**Re: Parking Expansion for Dr. Haltom
10433 Lagrima De Oro
Traffic Circulation Layout - Revised
Engineer's/Architect's Stamp dated 8-28-15 (F21-D052)**

**Re: Parking Expansion for Dr. Haltom
10433 Lagrima De Oro
Traffic Circulation Layout
Engineer's/Architect's Stamp dated 7-28-15 (F21-D052)**

**RE: Haltom Dental Office
10433 LaGrima Del Oro NE
Grading and Drainage Plan
Engineers Stamp Date 8/3/15 (F21D052)**

RE: **Haltom Dental**
10433 LaGrima Del Oro NE
Grading and Drainage Plan
Engineers Stamp Date 7/1/15 (F21D052)

ENGINEER'S SEAL	LAGRIMA DE ORO PARKING LOT DR. HALTON OFFICE GRADING AND DRAINAGE PLAN	DRAWING BY GEM	JOB # 100000
		DATE 9-17-18	SHEET # 1 of 1

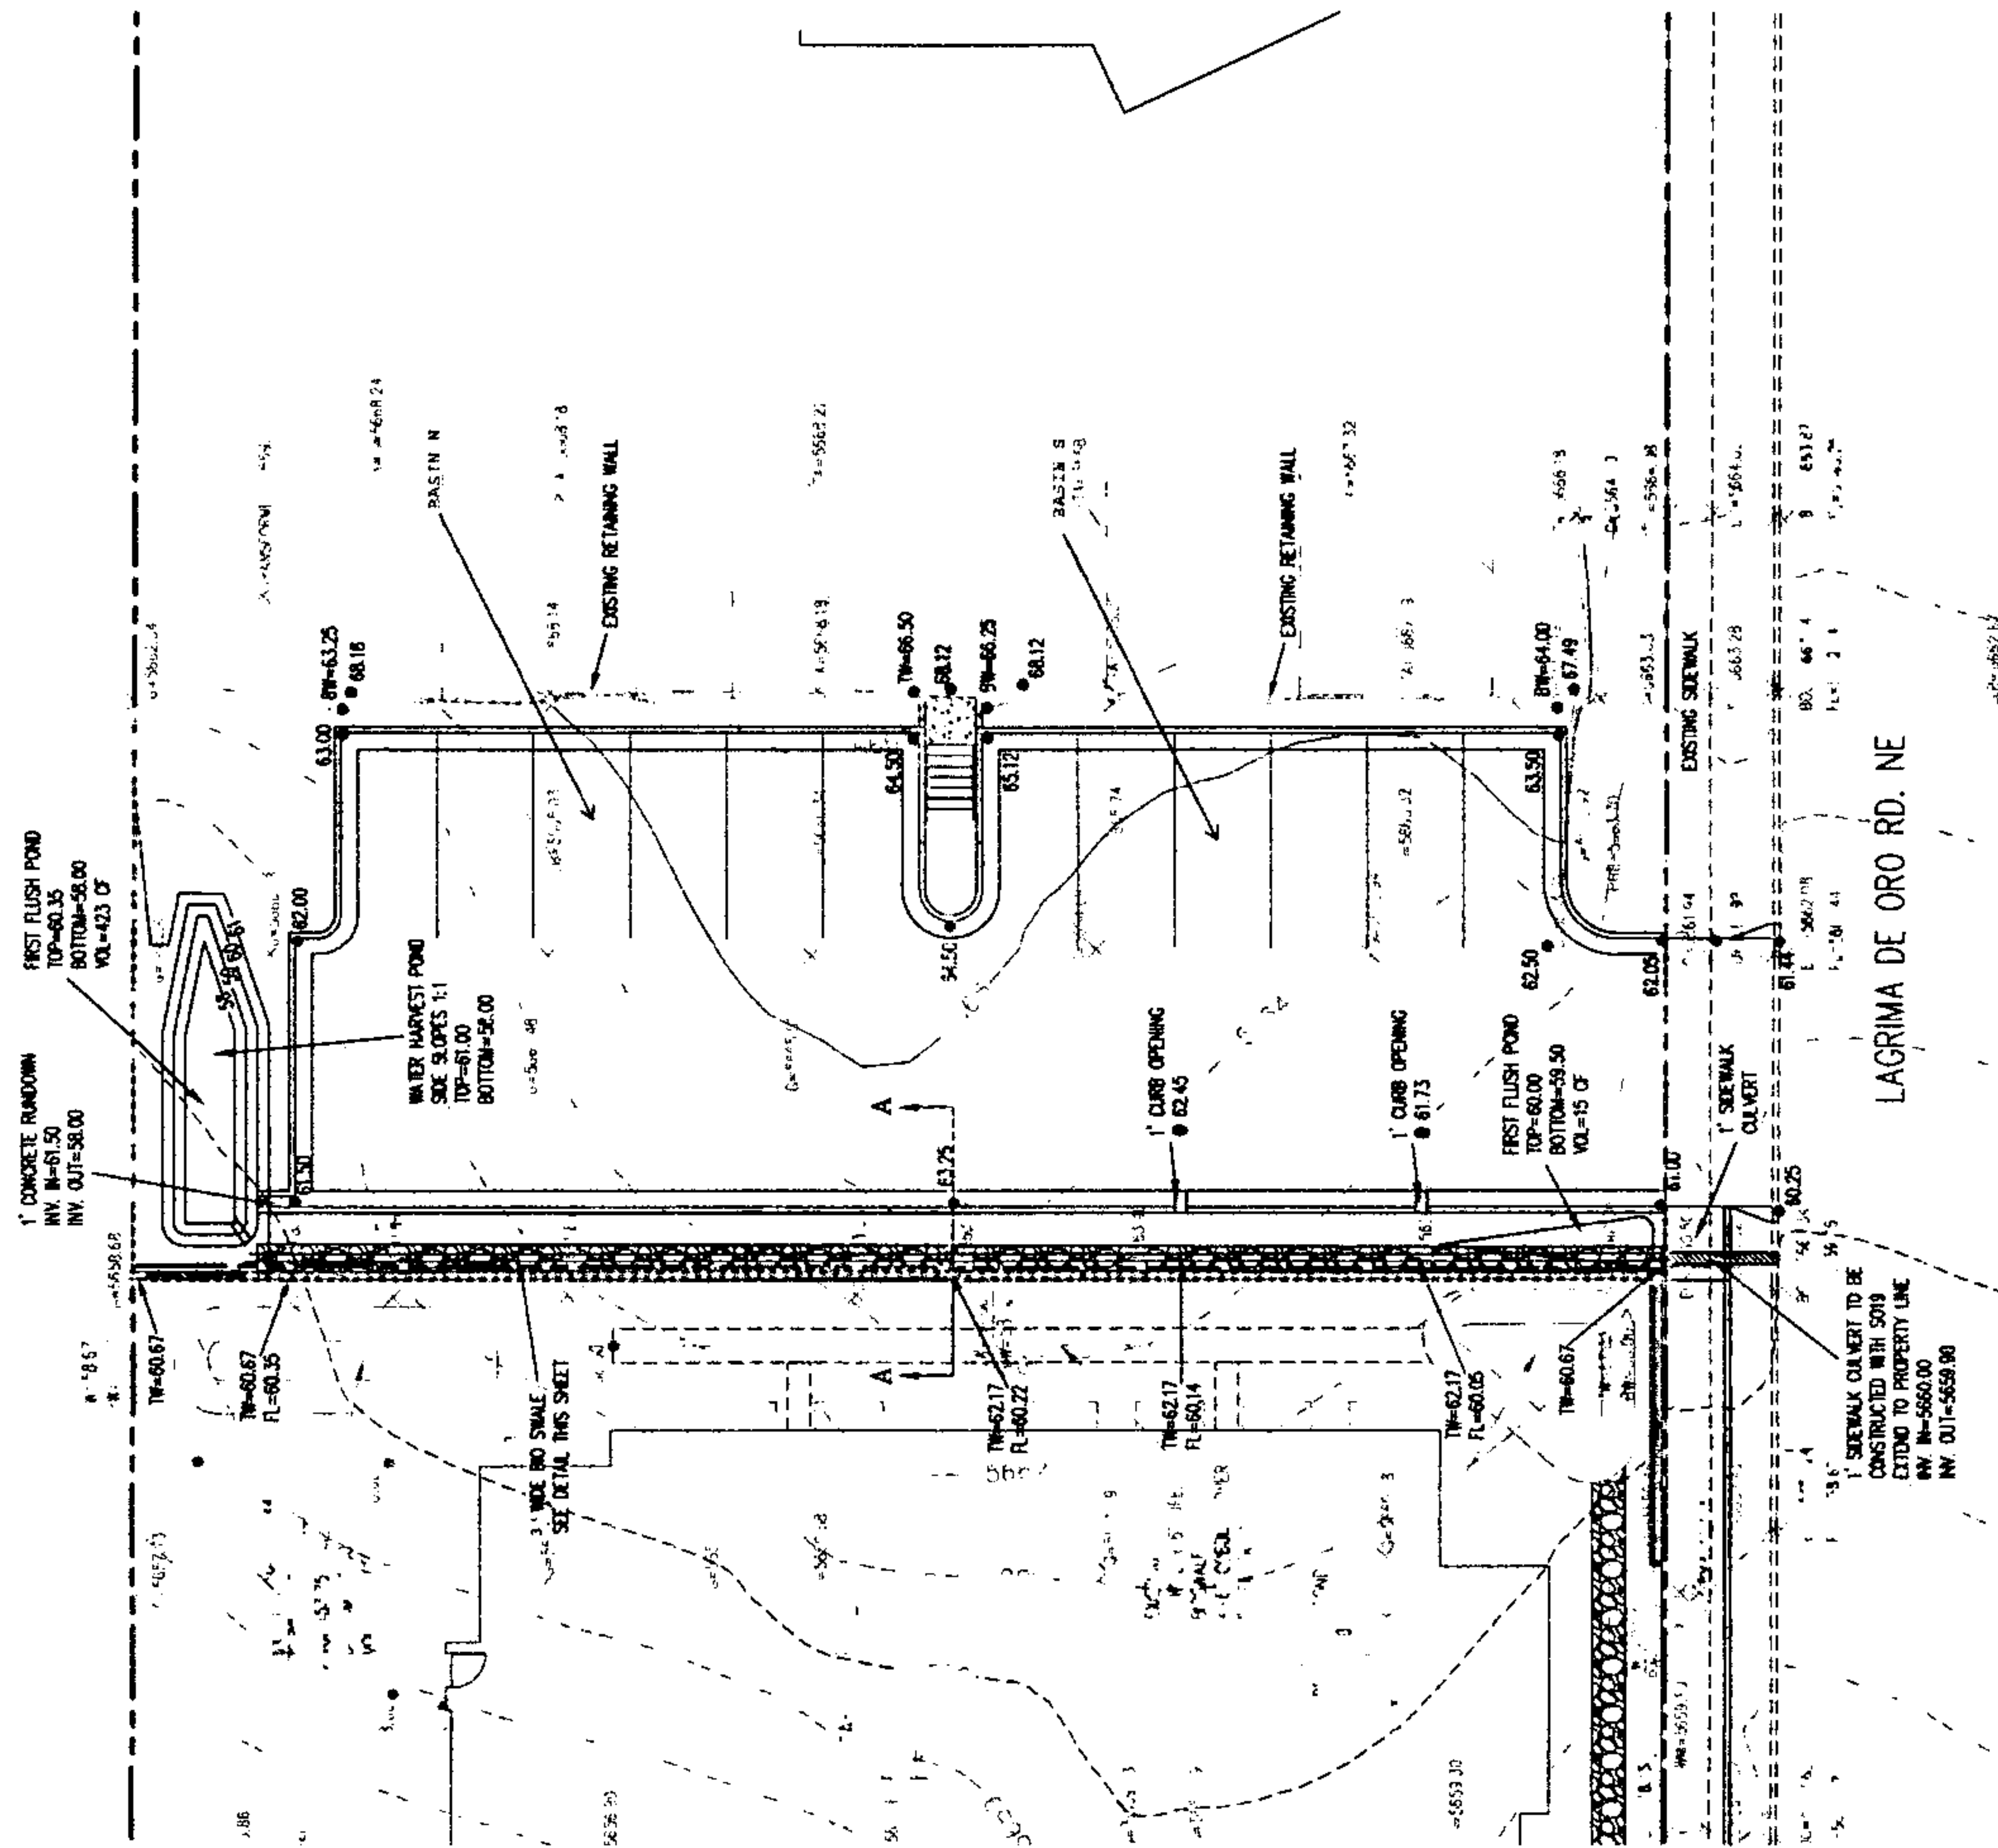
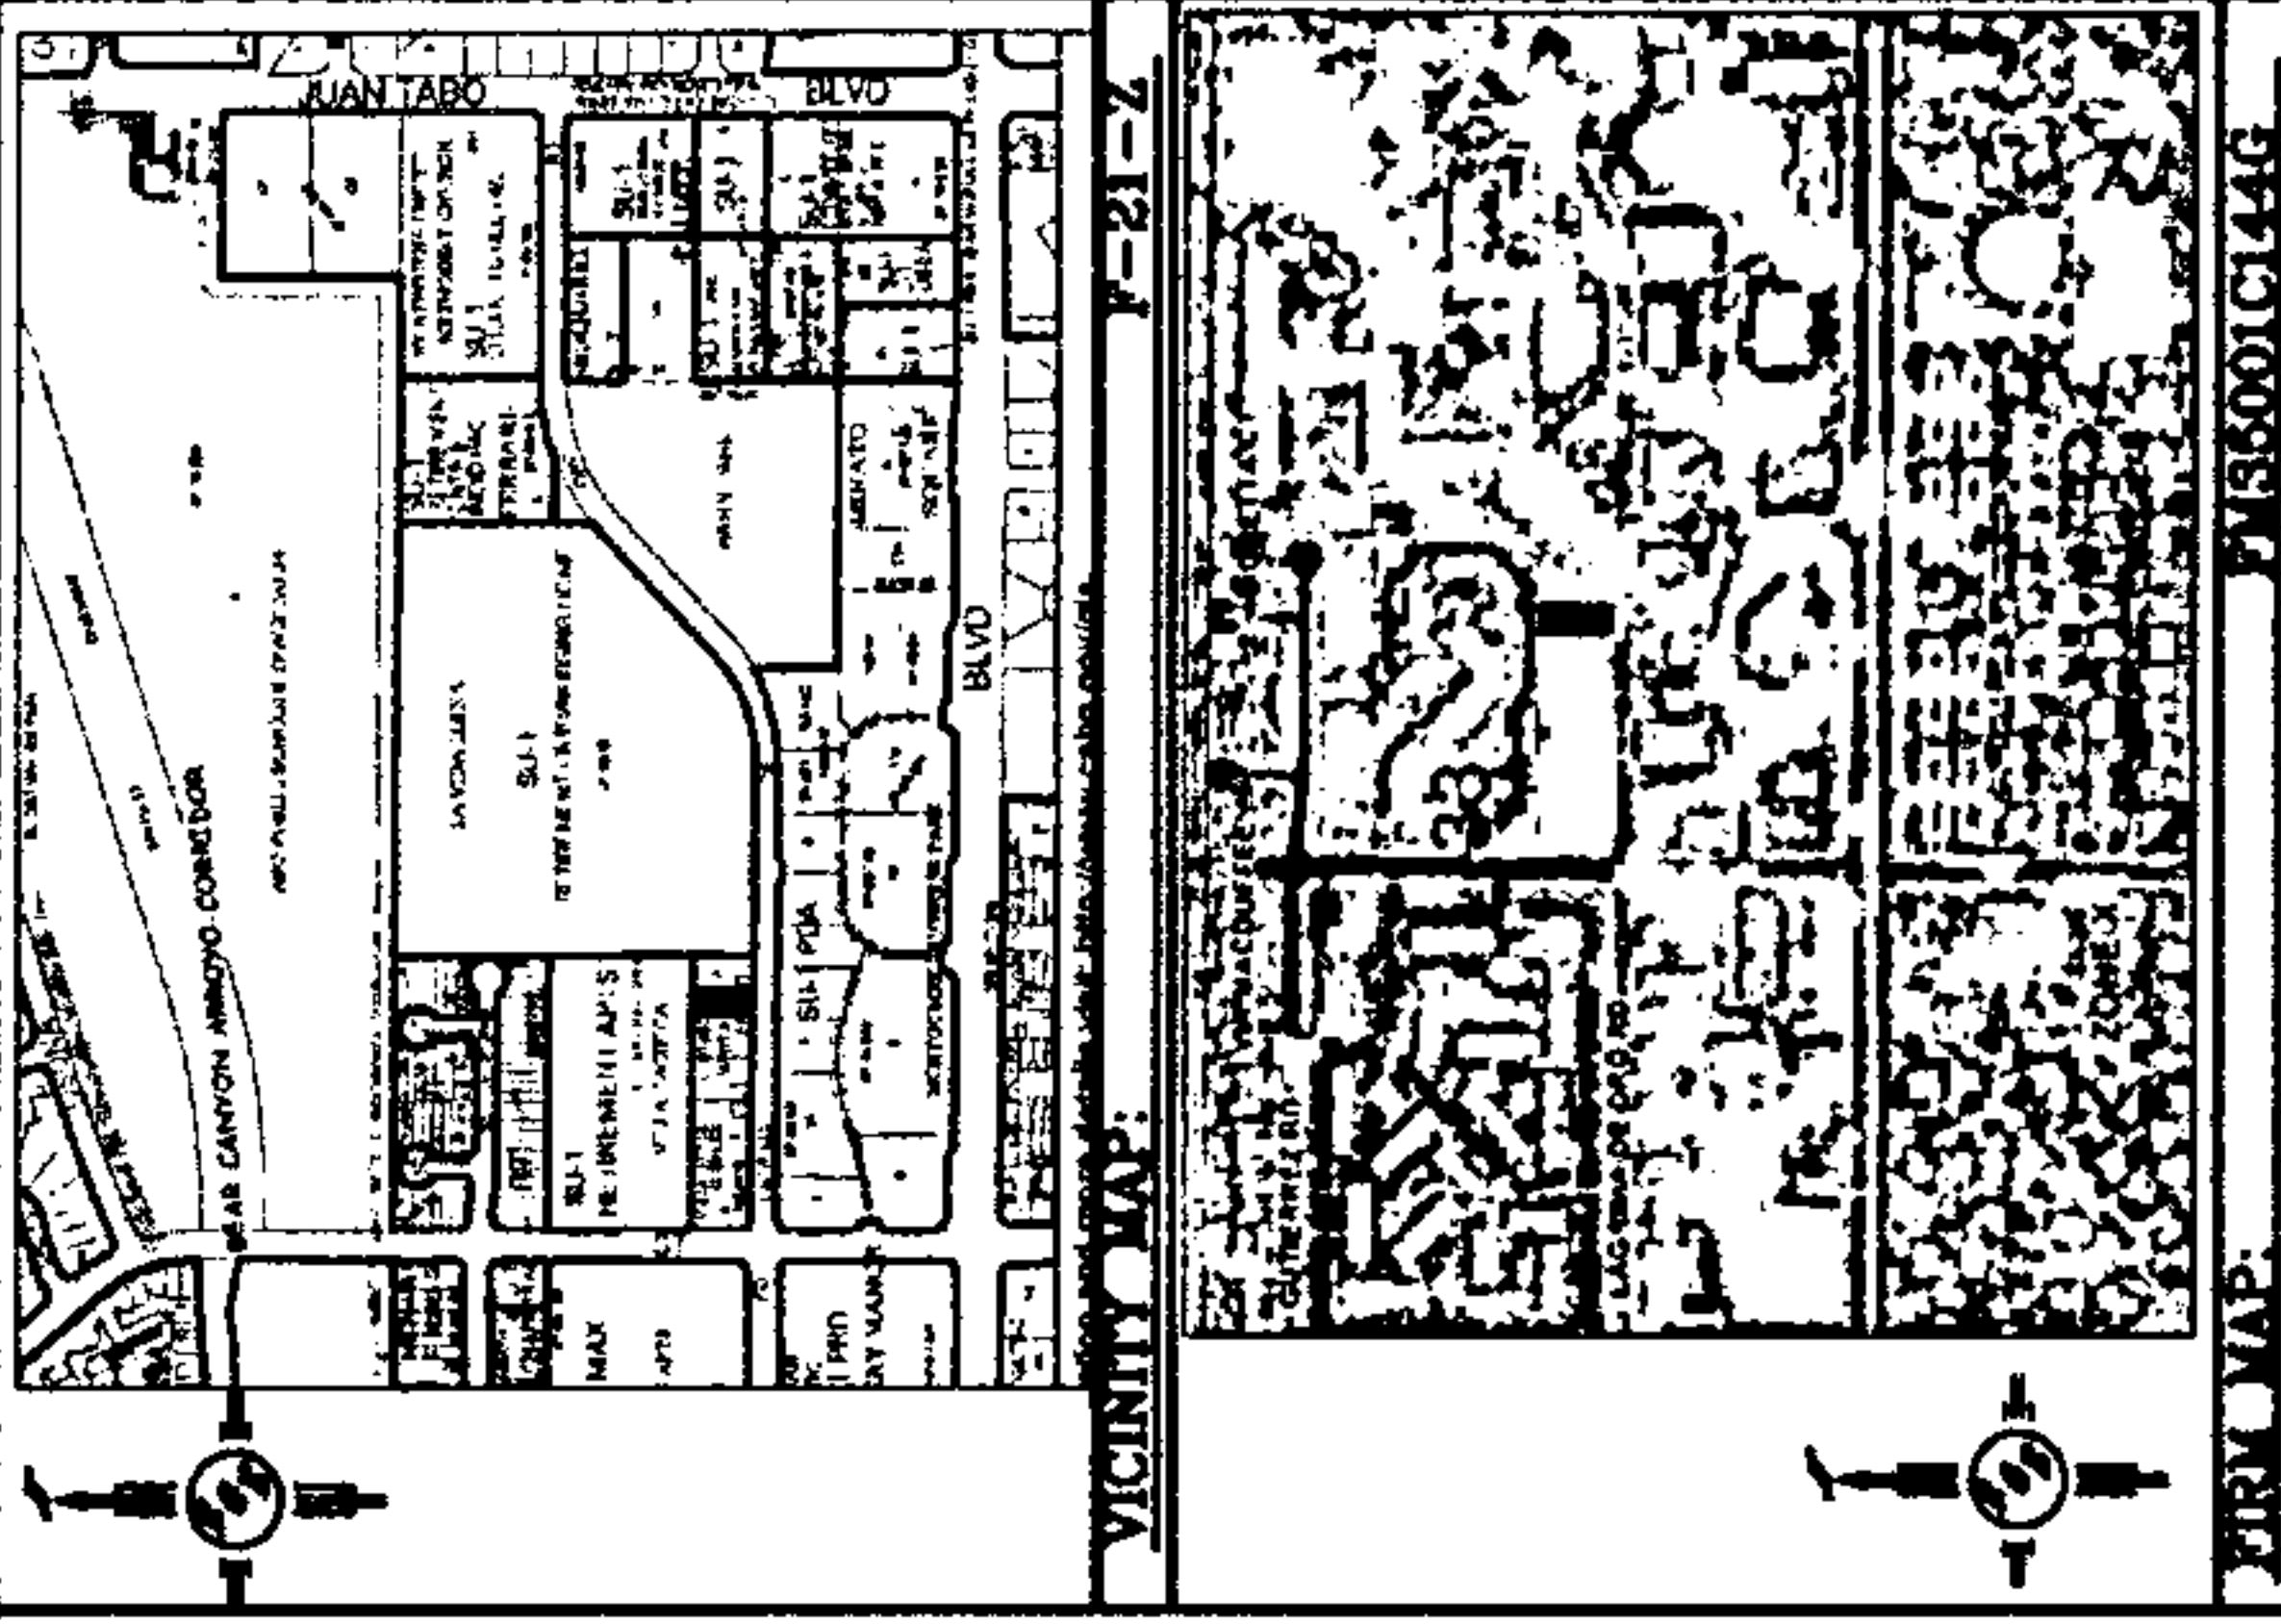
- Provide build notes on the G&D plan.
- Provide the benchmark.
- Provide a date on the signature line/remove X-XX-13.
- Provide a curb cut in the Southeast corner of parking lot.
- Depress all landscaping areas.
- Provide spot elevations along swale.
- Provide invert at beginning of swale.
- Show location of wall in Bio Swale Detail.
- Extend sidewalk culvert 2 feet inside property line.

- Provide build notes on the G&D plan. **ADDED**
- Provide the benchmark. **ADDED**
- Provide a date on the signature line/remove X-XX-13. **ADDED**
- Provide a curb cut in the Southeast corner of parking lot. **ADDED**
- Depress all landscaping areas. **ADDED**
- Provide spot elevations along swale. **ADDED**
- Provide invert at beginning of swale. **ADDED**
- Show location of wall in Bio Swale Detail **ADDED**
- Extend sidewalk culvert 2 feet inside property line. **ADDED**
